Re: Docket # 499 - Homeland/ AT&T/Sherman

Comments and Concerns Regarding Environmental Compatibility

**Subject: Proposed Telecommunication Tower
16 Coote Hill Road
Sherman, Connecticut**

**Reference: Application to Siting Council
Docket No.499 – Homeland Towers, LLC and New Cingular Wireless
PCS, LLC d/b/a AT&T**

Figure TP-2 Diagram of Zones Relating To Tree Protection

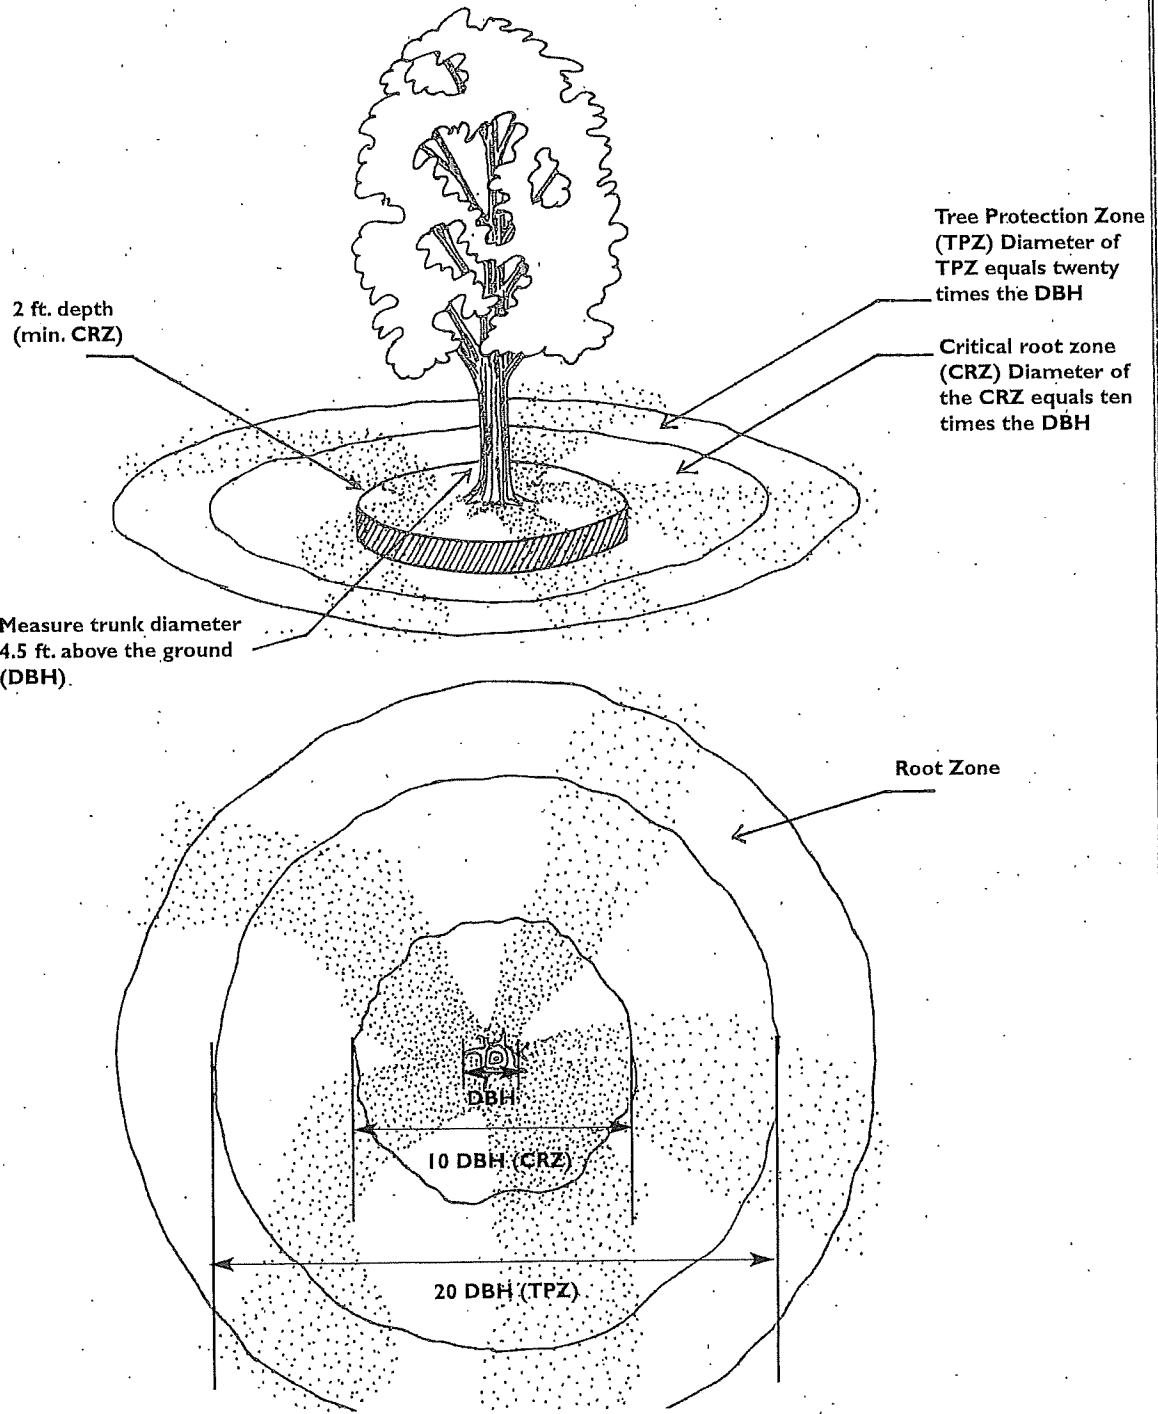
disturbance. Root systems usually extend to the drip edge of the crown. Depending on their size, many of the trees at the edge of the grading areas and between the proposed road/driveway and the wetlands will be cut or lost due to soil compaction or root exposure. Reference Chapter 5-1-6, Figure TP-2 "Diagram of Zones Relating To Tree Protection" in the 2002 Connecticut Guidelines for Soil Erosion and Sediment Control. Tree Protection Zone (TPZ) Diameter of TPZ equals 20 times the DBH (Diameter 4.5' above the Ground)(See Exhibit 2). Relocating the road/driveway to the alternate location will ensure a buffer will be maintained along the wetlands where in some locations the proposed road/driveway would be constructed within 10' to 20' of the edge of the wetland soils. This can result in a change of the hydrology and hydrogeology of the wetlands. The removal of the tree canopy near the wetlands will allow sunlight into wetland areas that were once shaded. This will change the vegetation and introduce invasive species.

SHEET NUMBER:
SP-2

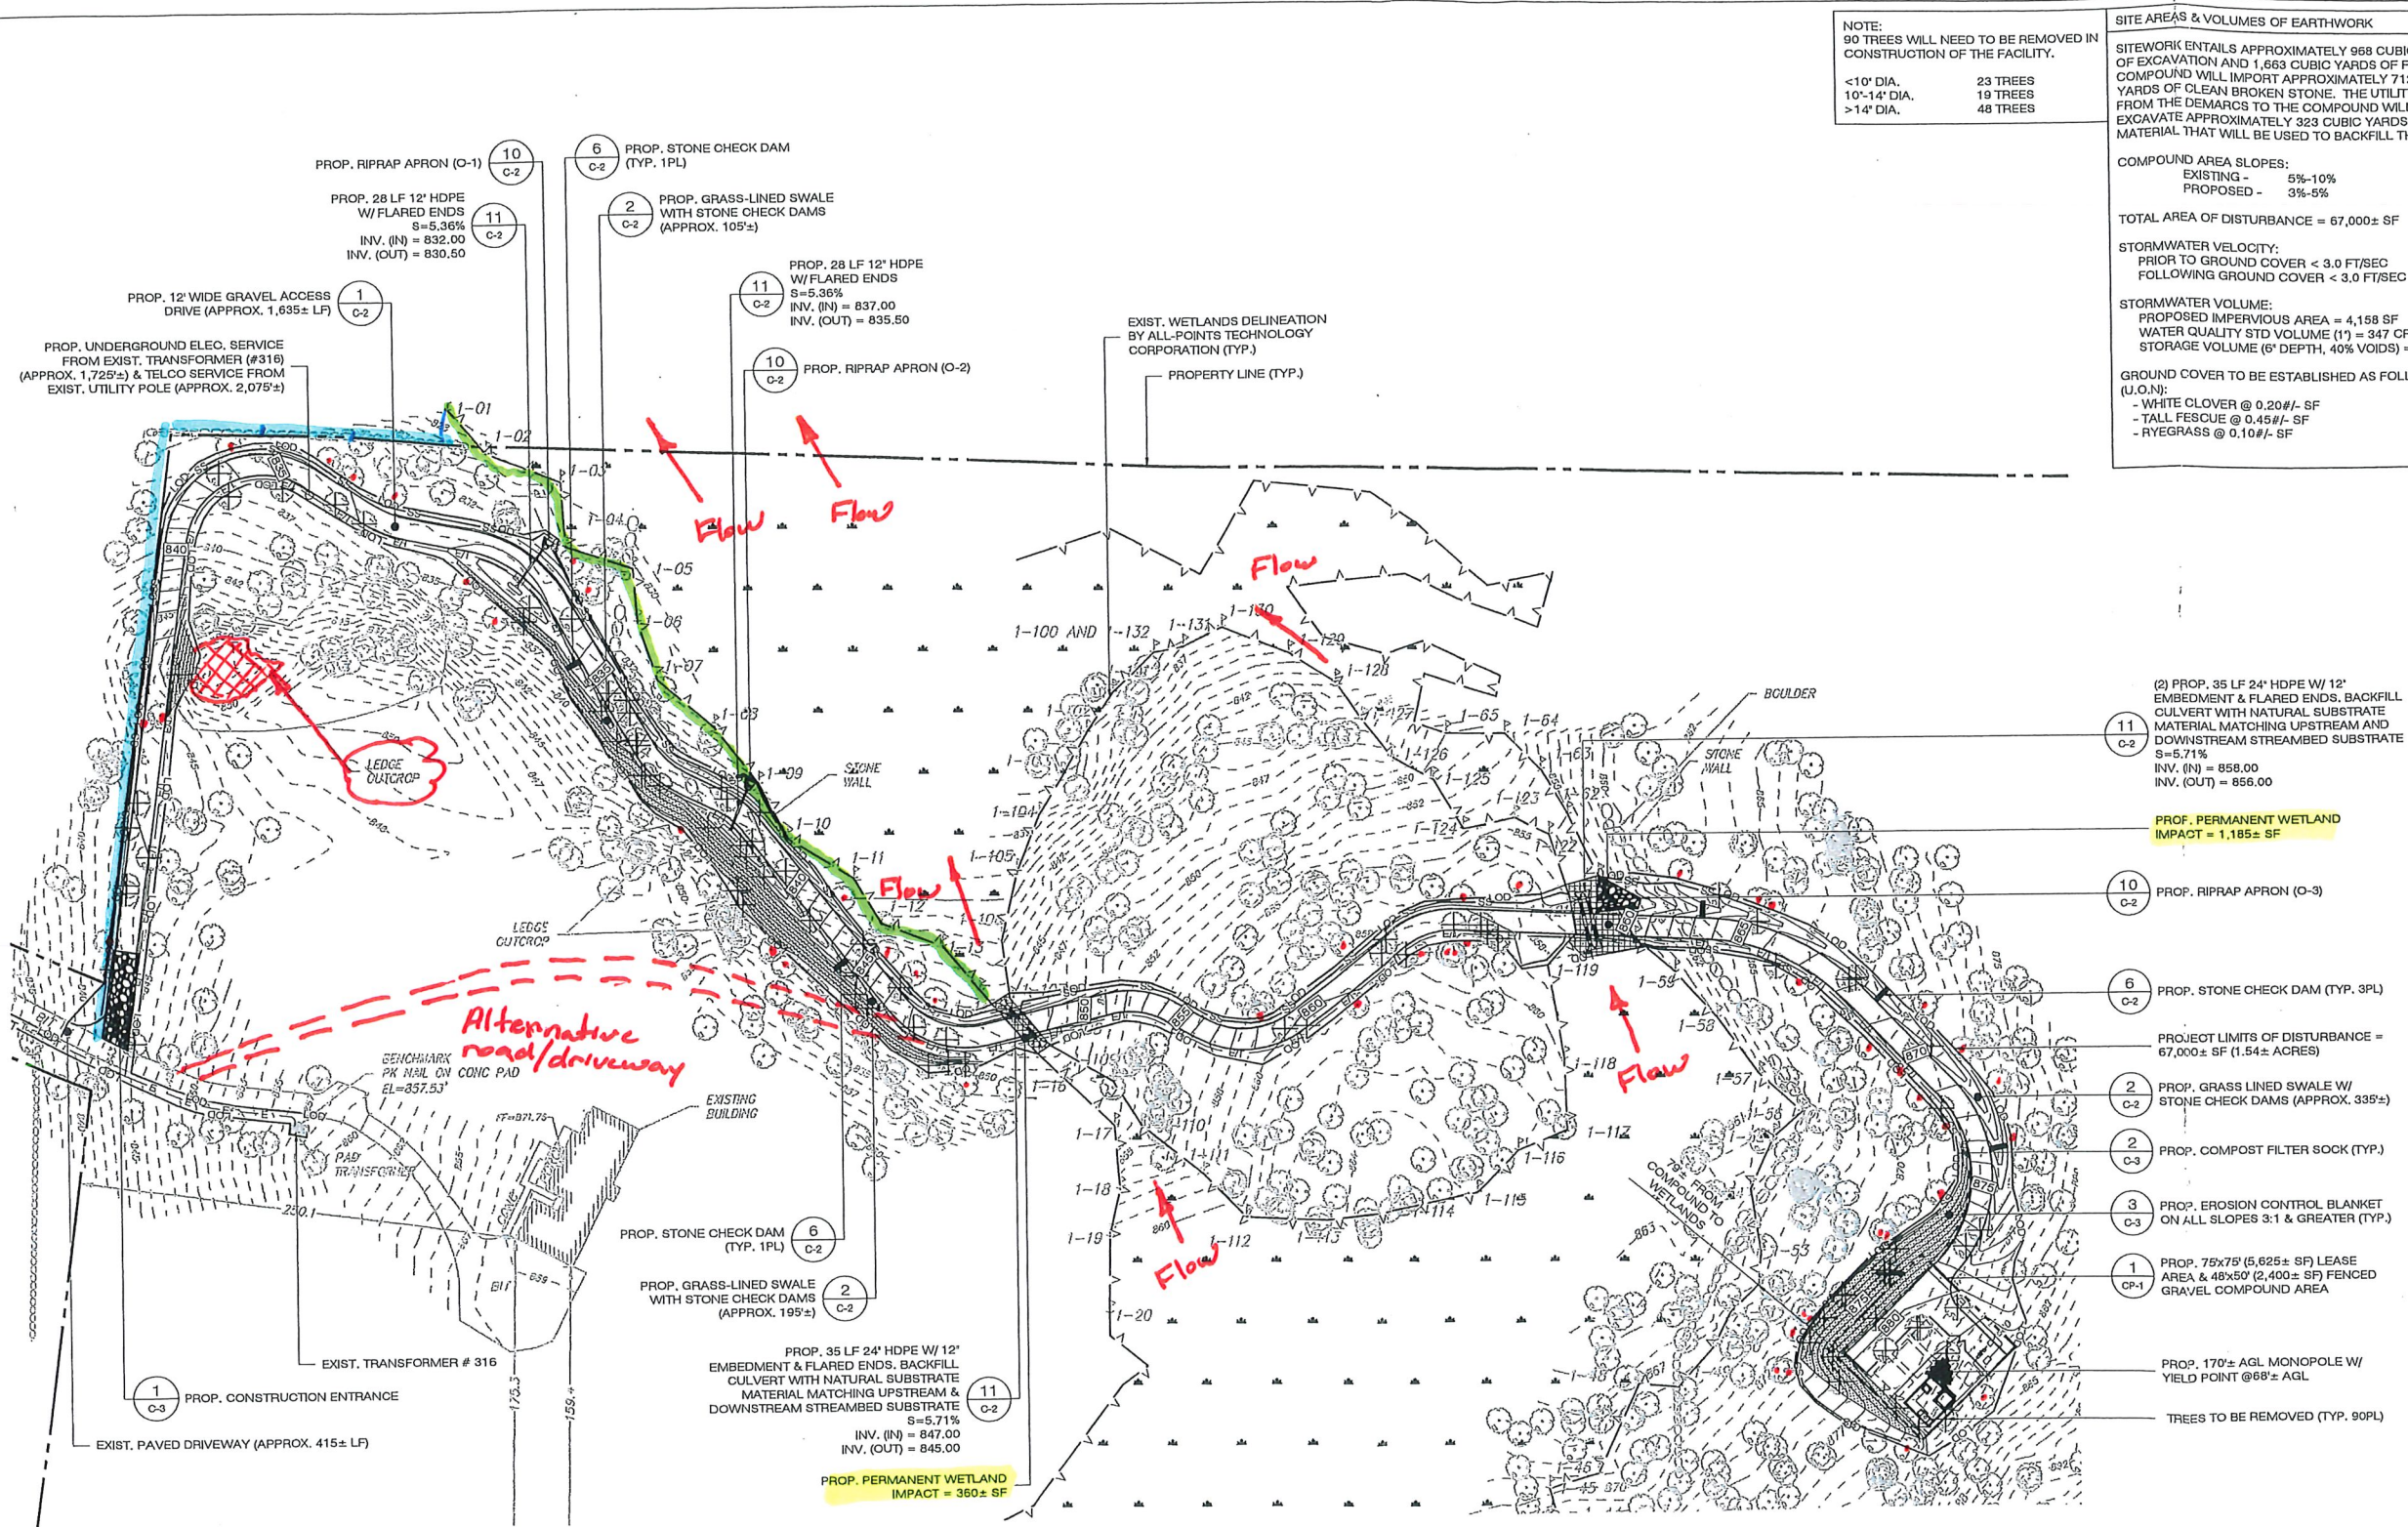
Partial Site Plan SP-2 shows the relocated road, tree locations, trees that are proposed to be cut/removed, topography, wetland delineation, proposed tower location/pad, proposed drainage and required road construction grading. With no storm water calculations, planned erosion controls, no planting planning, limited topography of the entire site and engineering details of the proposed storm water management and water quality plan this is a general review with comments of what was provided.

Along the proposed driveway/road along the wetlands near the northerly most property line, a cut is proposed on the southerly edge of the road. This creates approximately a 2:1 slope for approx. 300' and in one area 25' wide that is void of vegetation on the slope and at the crest of the slope where trees have to be cut. See Section entitled: "Number of trees cut", "More prudent alternative" and "Run-off" of this report. The proposed area of the steep slope should be reviewed carefully. There is a high probability that ground water will seep out of this embankment causing instability to the slope where you could expect to see "sluffing" of material. The entire area should be covered with temporary erosion blankets and planted with vegetation for long term stability. During construction, if ground water surfaces on the slope or at the toe of the slope, the site should be reviewed by an engineer and the appropriate drainage should be installed. An appropriate Vegetative Soil Cover should be planted on all disturbed area on completion of the grading.

- **More prudent alternative** – The length of the driveway/road can be reduced by relocating it in a more direct path away from abutting properties and the length of wetlands located to the north. The relocated driveway/road will reduce the amount of hard (impervious surface), reduce the number of trees needed to be cut for construction, eliminate a sharp bend in the road that will be troublesome to maneuver sections of the tower around during construction, eliminate the adverse impact to abutting properties and the wetlands where storm water is intended to sheet flow off, eliminate the need for ledge removal approximately 200' from the start of the driveway/road, and eliminate the long grading bank (cut) on the uphill side of the driveway/road along the wetlands. **(See Exhibit 1).**

- **Number of Trees Cut** – The number of trees shown on the plan that are proposed to be cut appear to be under estimated. The trees they recognize for removal have an X through them, but further examination shows tree trunks located at the edge of the proposed grading. The grading will either expose tree roots or bury them to the point where the tree will be choked and killed. When looking at the plan the trees are shown with a symbol that would lead you to believe the tree crowns are only 10'-12' in diameter. Many of the trees on the property are over 20 to 30' or greater in height. These trees have crowns greater in diameter reaching far into the areas proposed for

- **Alternative Site Design:** The most important improvement to the design would be to relocate the proposed road/driveway to the proposed alternate location shown on the attached marked up plan (**Exhibit 1**). I have been on the property and the alternate location is feasible. This will accomplish the following:

Impact to neighbors
Impact to wetlands

Total area of wetland taking = 1545±

Alternative road/drainway
